Difficulty Closing Glove Box

Market USA

YEAR(S)	MODEL(S)	ADDITIONAL INFORMATION
2009	Matrix

Some 2009 model year Matrix vehicles may exhibit a condition where the latch on the LEFT side of the glove box will not properly engage the instrument panel causing the glove box door to fall open and making it difficult to close. The following repair procedure has been developed to correct this condition.

Figure 6.

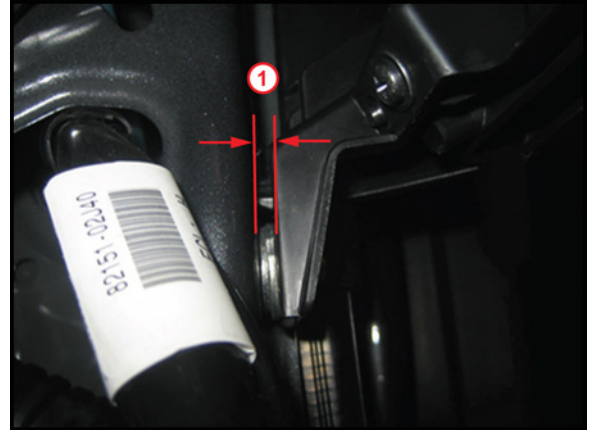
7. Gently pull back the lower RIGHT side of the lower instrument panel and insert a 4 mm (5/32 in.) thick washer between the lower instrument panel and the body of the vehicle as shown in Figure 6.

8. Reinstall the lower instrument panel bolt with the 4 mm (5/32 in.) washer in the center.
9. Reinstall the RF cowl side trim board, RF door scuff plate and the glove box door.
10. Verify that the latch on the LEFT side of the glove box door properly latches into the instrument panel and that the glove box door remains closed.
